APPLICATION NO.	FILING DATE	FIRST NAMED INVENTOR	ATTORNEY DOCKET NO.	CONFIRMATION NO.
10/806,872	03/22/2004	Steven E. Summer		3870

Office Action Summary

DETAILED ACTION

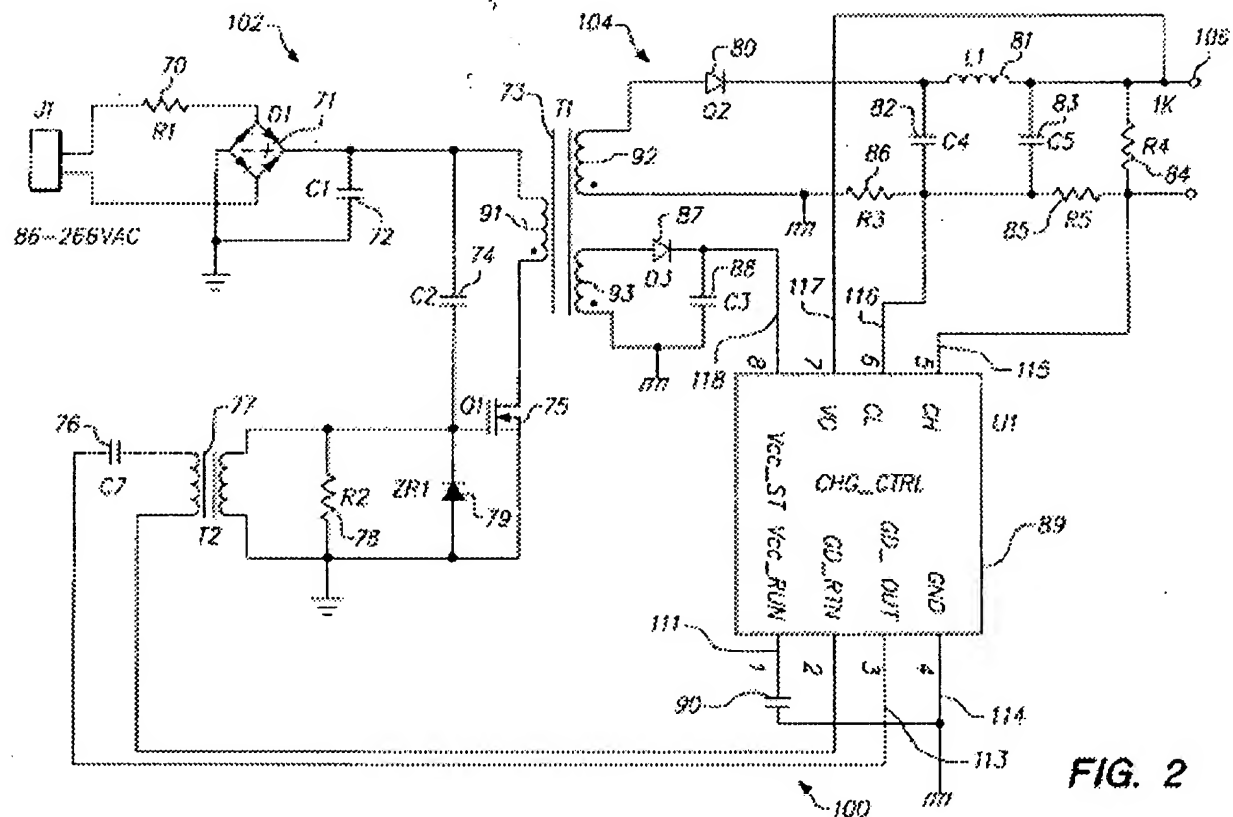
Claims 1-12 and 19-23 are rejected under 35 U.S.C. 103(a) as being unpatentable over Wong (USP 6,456,511) in view of Shimashita (USP 5,661,642). Wong discloses the

claimed invention (see figure 3 below), a drive circuit, a drive pulse transformer (T2), a de-coupling capacitor (C1), an output rectification circuit (80), a capacitor (C7) connected between the pulse width modulator and the primary windings, a zener diode (ZR1), a bleeder resistor (R2), a flyback transformer (T1), a rectifier diode (80, 87) except for the isolation circuit that is used to isolate the input line from the output line. Shimashita discloses that it is known in the art to provide the isolation circuit that is used to isolate the input line from the output line. Shimashita discloses an isolation (15) circuit that is used to provide a clean signal for the control of the switching circuit. It would have been obvious to one having ordinary skill in the art at the time of the invention was made to provide the isolation (15) circuit that is used to provide a clean signal for the control of the switching circuit of Shimashita with the drive circuit, a drive pulse transformer (T2), a de-coupling capacitor (C1), an output rectification circuit (80), a capacitor (C7) connected between the pulse width modulator and the primary windings, a zener diode (ZR1), a bleeder resistor (R2), a flyback transformer (T1), a rectifier diode (80, 87) of Wong, in order to provide a signal that is cleaner and has less noise and electrical effects that would tend to contaminate the signal without an isolation circuit.
